REVISION OF CITY OF BEAVERTON STANDARD DRAWING NO. 310 7-13-04

**ATTENTION! THIS DRAWING REPLACES
DRAWING NO. 310, DATED 6-10-04**

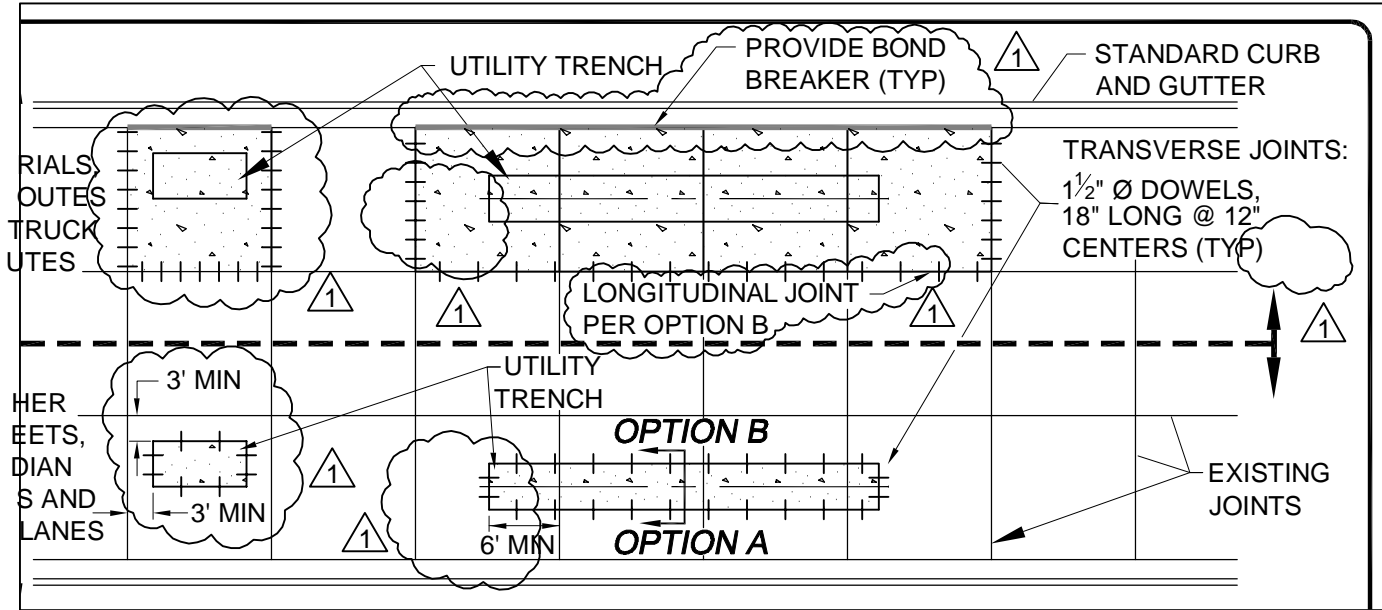
1. ADDED CALL-OUT "LONGITUDINAL JOINT PER OPTION B" TO PLAN VIEW. REMOVED TIE BARS FROM CURB JOINT. ADDED SHADED LINE AND CALL-OUT TO REPRESENT BOND BREAKER ON UPPER CURB. ADDED SCENARIO FOR UTILITY TRENCH CONTAINED WITHIN ONE PCC PAVEMENT PANEL. REMOVED "SEE NOTE 1" FROM TRANSVERSE JOINT CALL-OUT. CHANGED THE SAWCUT DEPTH TO $\frac{1}{3}$ FROM $\frac{1}{4}$, AND ADDED "SEAL THE NEW JOINTS PER THE ENGINEERING DESIGN MANUAL," TO NOTE #7.

5. If utility trench wall must be closer than 3 feet from the joint, then remove pavement to the joint.
6. When panels are offset or irregular in any manner, the City Engineer shall determine the area of pavement replacement.
7. After placement of pavement, re-sawcut the joints that intersect the trench. The depth of sawcut is to be $\frac{1}{3}$. Seal the new joints per the *Engineering Design Manual*.
8. If pavement is undermined during repair, sawcut and remove pavement back to undisturbed subgrade.
9. If pavement is damaged during repair, sawcut and remove back to undamaged pavement.
